SAN FRANCISCO PLANNING DEPARTMENT

Discretionary Review Abbreviated Analysis

Date: October 1, 2015
Case No.: **2014-000595DRP**
Project Address: **2720 Lyon Street**
Permit Application: 2014.06.11.8149
Zoning: RH-1 (Residential, House, One Family)
40-X Height and Bulk District
Block/Lot: 0948/031
Project Sponsor: Jeff Eade, Architect
407 Crestmont Drive
San Francisco, CA 94131
Property Owners: Katherine Treasure & Rick Burroughs
2720 Lyon Street
San Francisco, CA 94123
Staff Contact: Sara Vellve – (415) 558-6263
sara.vellve@sfgov.org
Recommendation: **Do Not Take Discretionary Review and Approve as Proposed**

Views of 2710 Lyon St. Entryway courtyard which
was mischaracterized AS "Light well" during
entire planning Department consideration.

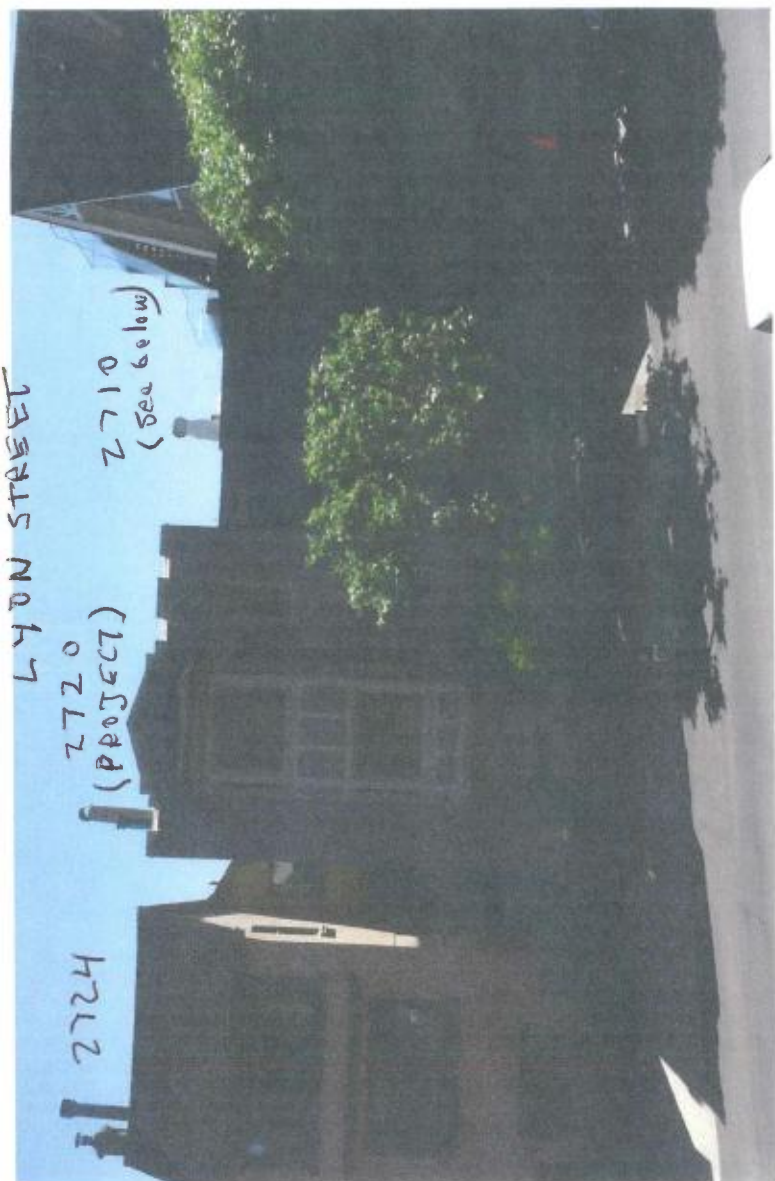
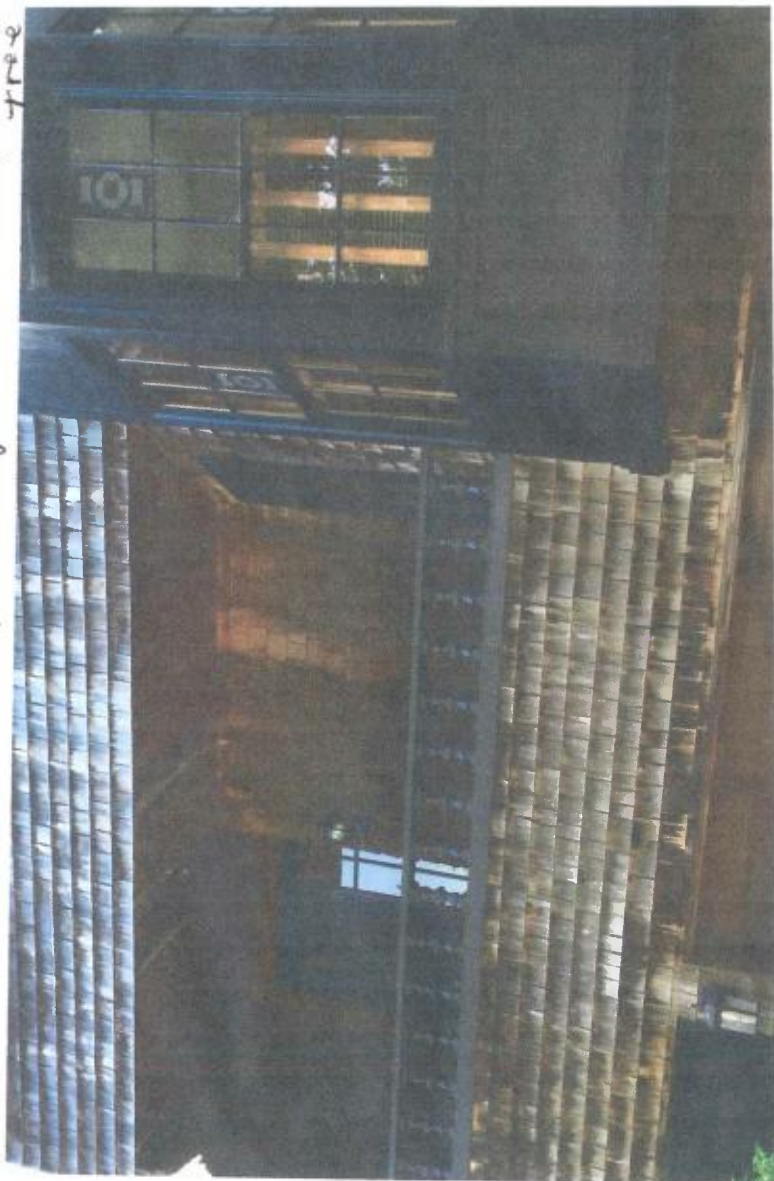
The 3rd floor balcony newly introduced by the plans mailed to neighbors in May 2015 via 311 Notification affords a direct line of sight into 2724 Lyon Street's master bedroom windows. The 3rd floor balcony should be eliminated or modified to eliminate this intrusion of privacy, through a setback from the East and /or North.
